Application for Variation of an Environmental Permit

C2. Application No. of the Current Environmental Permit : AEP-553/2018

Agreement No. CE 32/2017 (CE)
Yuen Long South development – stage 1
– Design and Construction

Environmental Review for Application for VEP (EP-553/2018)

Plate 1.3 Proposed drainage arrangement incorporating traffic / mitigation measures

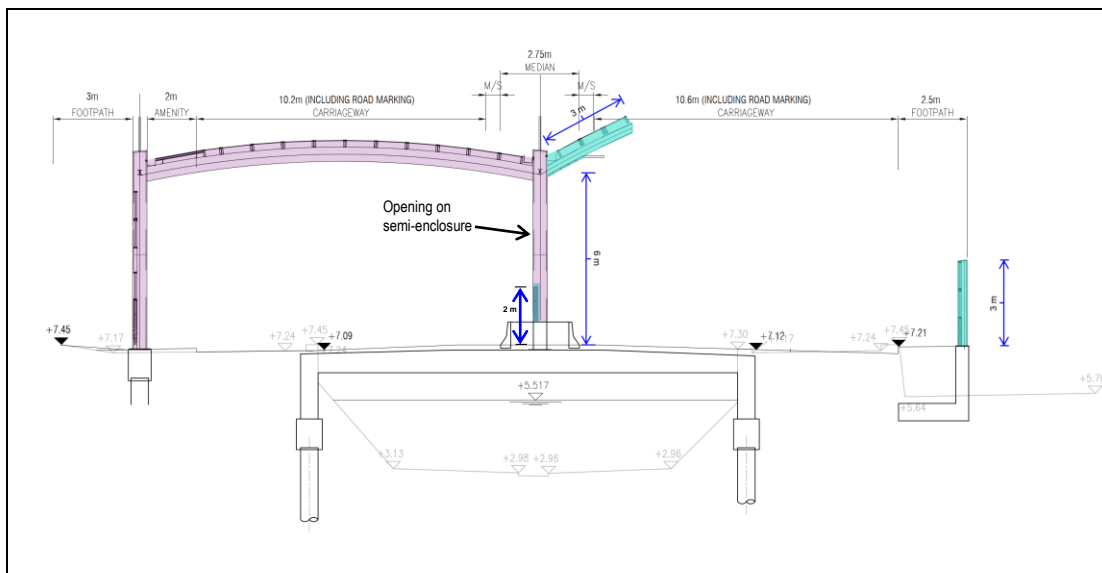
- 1.1.3 According to the engineering design for coping with traffic needs, safety, hydraulic performance and constructability considerations, it is revealed that a section of 240m-long proposed partial decking with box culvert and revitalised open channel in **Plate 1.2** (between Shap Pat Heung Road and Yuen Long Highway) will not be feasible to be implemented. In order to provide sufficient safety consideration (desirable sight distance to road-users) and minimise impact to existing private residential developments alongside Kung Um Road, the proposed roadworks would be realigned on top of the existing Yuen Long Nullah. The proposed full decking arrangement as shown in **Plate 1.3** shall anticipate a certain noise impact during the operation phase. However, further review/assessments on the proposed noise mitigation measure shall be required for verifying whether these proposed changes will constitute a variation of Environmental Permit (to EP No 553/2018). The adopted traffic data for traffic noise assessment has been tabulated in **Appendix 1**, this is same as the set of traffic data for the approved YLS EIA report and ERR for Revised RODP Review which had been accepted by TD in 2019 (refer to **Appendix 2**).

Plate 1.4 Extent of Decking along Kung Um Road and Kiu Hing Road under Environmental Permit No. EP-553/2018 for Yuen Long South development

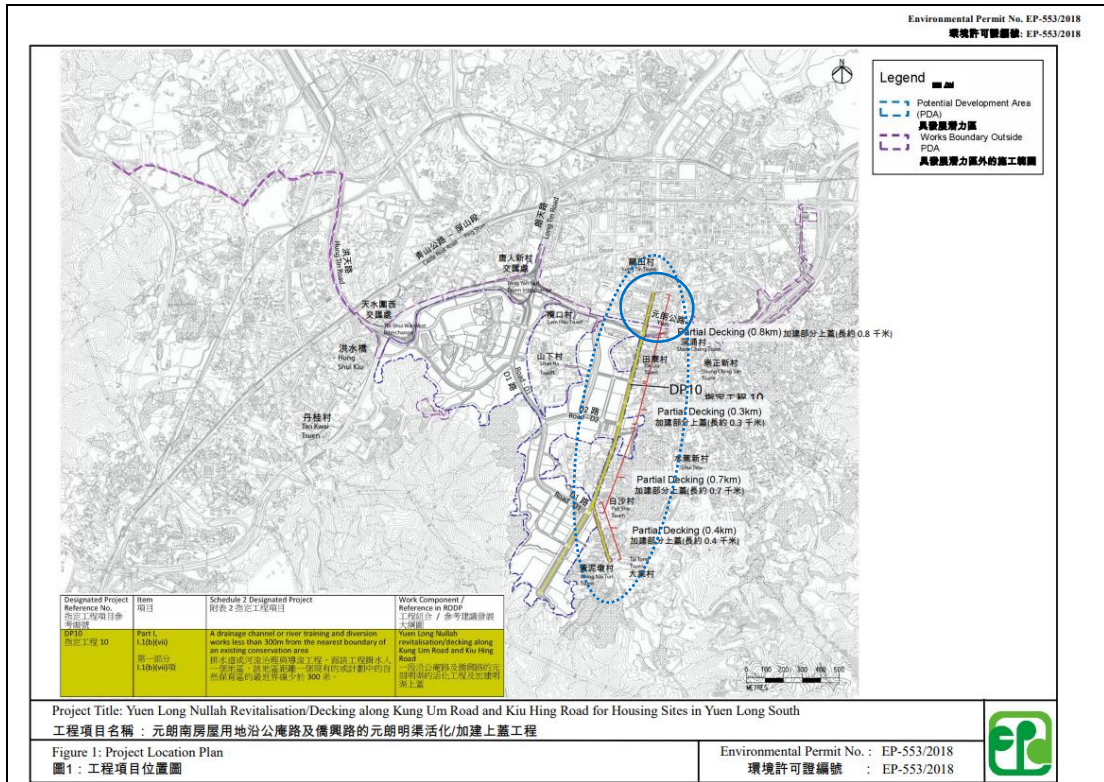
1.2.1 An Environmental Permit, EP-553/2018, was issued by EPD for the construction works of the Yuen Long Nullah revitalisation/decking (~2200m in length) along Kung Um Road/Kiu Hing Road (see **Plate 1.4** for extent of DP10). The specific conditions for this EP are summarized below:

Plate 1.5 Proposed extent of full decking (~240m) under Environmental Permit No. EP-553/2018 for Yuen Long South development

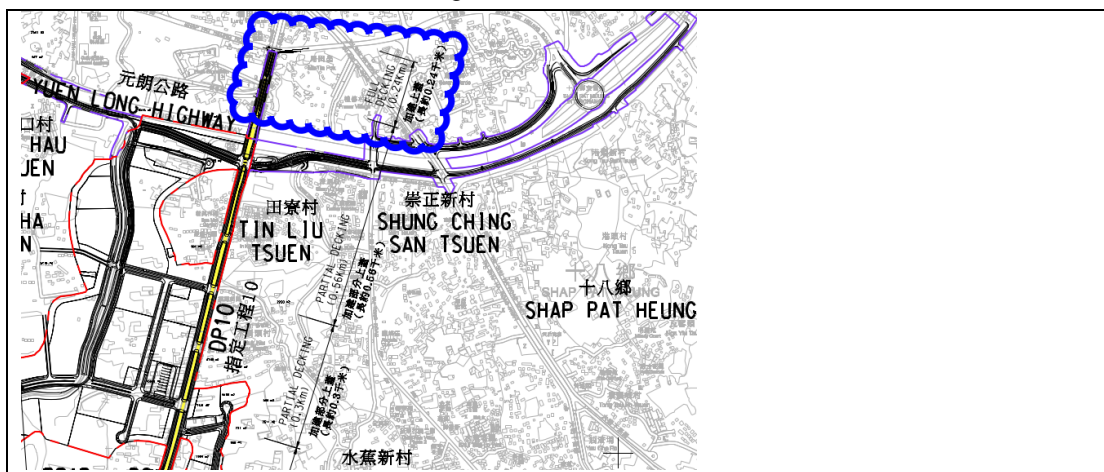
1.2.2 As illustrated in **Plate 1.5**, the section of the proposed full decking (~240m in length) of Yuen Long Nullah along Kung Um Road and Kiu Hing Road is sited between Shap Pat Heung Road and Yuen Long Highway. This full decking is far beyond 300m from nearest Conservation Area (Tai Lam Country Park area), and currently some high-rise residential developments have been built and area paved for brownfield operation, in view of the location / surrounding developments, apart from the required details as mentioned in the first 4 bullet points of **Section 1.2.1**, the below 2 submissions should be provided according to EP-553/2018 for this section of full decking:

- Submission of detailed Landscape and Visual Plan; and
- Submission of Traffic Noise Mitigation Plan.

Plate 3.1 Location of Planned R(A)1 and Two Concerned Noise Semi-enclosures

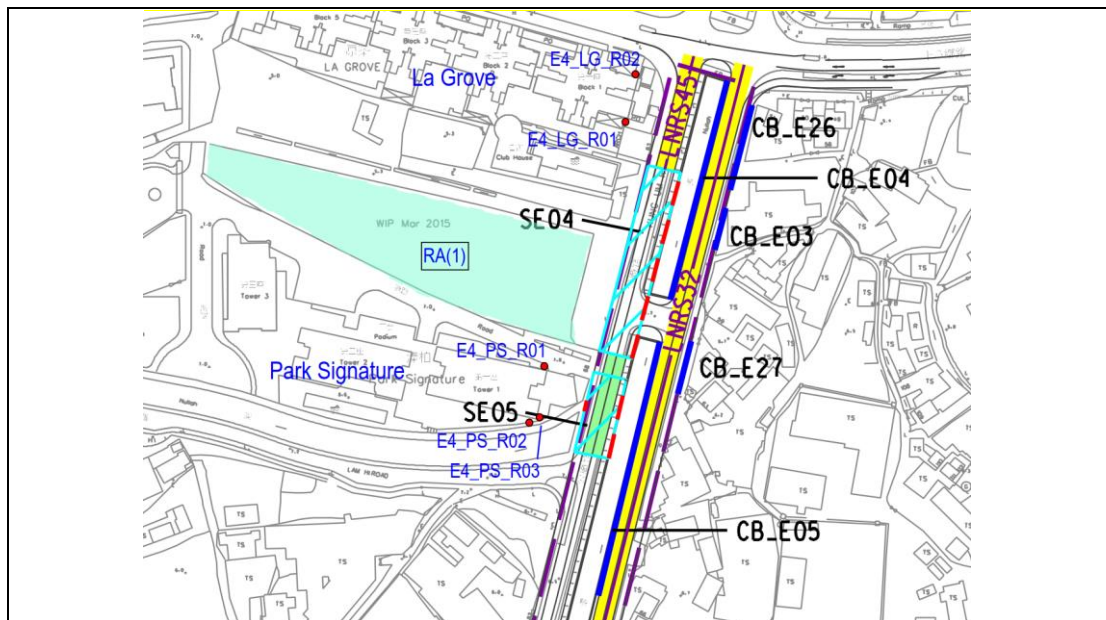
- 3.1.3 According to the draft Yuen Long OZP No. S/YL/24 as gazetted on 29 January 2021, the site between La Grove and Park Signature is zoned “Residential (Group A)1” (“R(A)1”). Semi-enclosures SE04 and SE05 were proposed to alleviate the noise impact to existing private development “La Grove” and “Park Signature”, as shown in **Plate 3.1** below. Referring to the finding of Appendix 5.16c of YLS EIA Report, some representative NSRs such as E4_LG_R02, E4_PS_R01 to E4_PS_R03 would still exceed the noise criteria 70dB(A), but exceedance is due to “other roads”. The noise contribution from “project road” is less than or equal 0.8dB(A).

Plate 3.2 Location of Hatched Road Marking on Kung Um Road

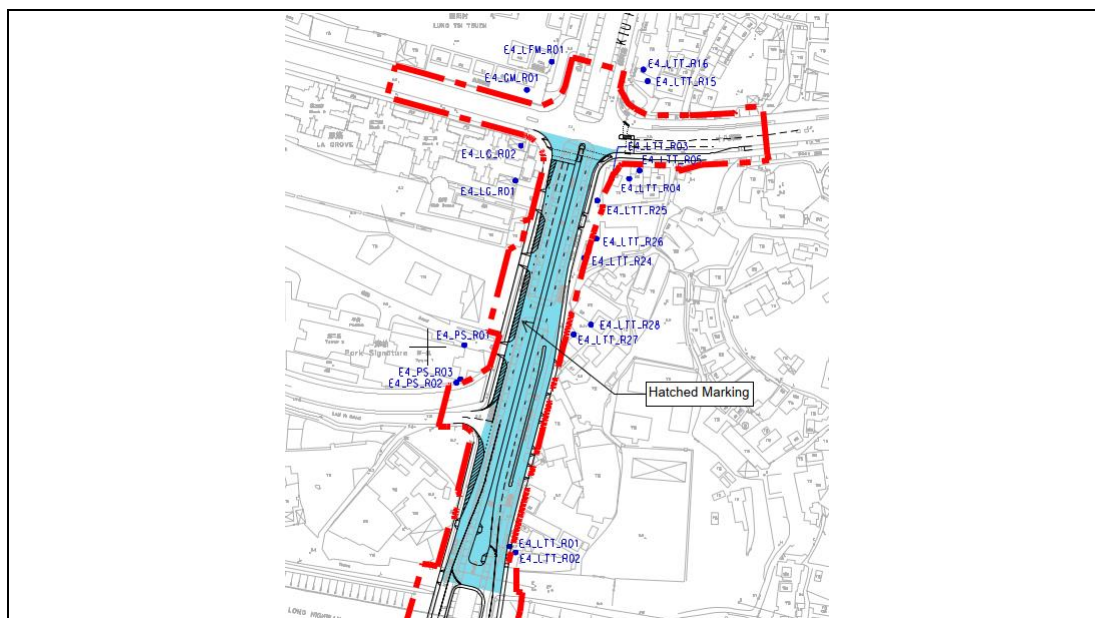
- 3.1.4 For the noise mitigation measures scheme considered in this review, in order to give a safer driving condition to the road-users (such as sight-line) along the road kerb of Kung Um Road, it is not viable to erect noise barrier at the road kerb by using non-transparent type noise barrier. For providing a safer driving environment to road-users, part of the Kung Um Road and Kiu Hing Road which were re-aligned towards the decked Yuen Long Nullah will be hatched with road marking to keep vehicles away from semi-enclosure/noise barrier. The hatched marking area is indicated in **Plate 3.2**.

Plate 3.3 Recommended Mitigation Measures for Kung Um Road and Kiu Hing Road

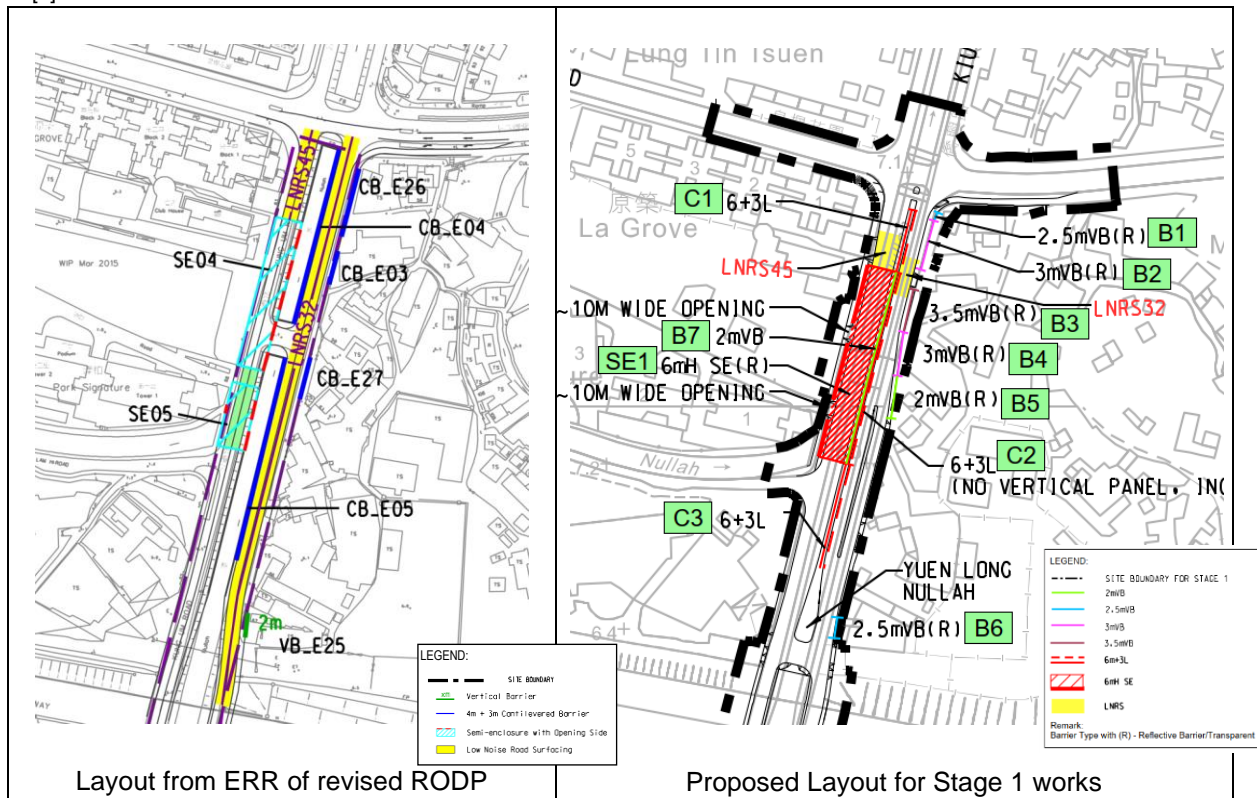
3.1.7 The predicted road traffic noise level in 2053 are summarized in **Appendix 4** while locations of proposed traffic noise mitigation measures including using of vertical barriers, cantilevered noise barrier, semi-enclosure as well as LNRS on residual impact are shown in **Plate 3.3**.

3.1.8 Summary of the proposed mitigation measures is listed in **Table 3.1** and indicated in **Plate 3.3**.

- 3.1.9 A section of Kung Um Road and Kiu Hing Road between Shap Pat Heung Road and Yuen Long Highway has been converted into full decking from partial decking. With the further removal of LNRS according to guidance note of HyD (RD/GN/011C), modelling result showed that some NSRs would be affected. However, this noise impact can be solved by adopting further mitigation measures such as noise barrier (semi-enclosed/vertical/cantilever type) or reprovision of LNRS at the concerned road section (as marked in **Plate 3.3**). Since there is no change to the NSRs, it is expected that noise mitigation measures for road traffic noise impact for other sections is still valid under the ERR for revised RODP.

- 3.1.10 Submission of Traffic Noise Mitigation Plan shall be required for full decking of Yuen Long Nullah no later than one month before the commencement of construction of the Project as per environmental permit no. EP-553/2018.
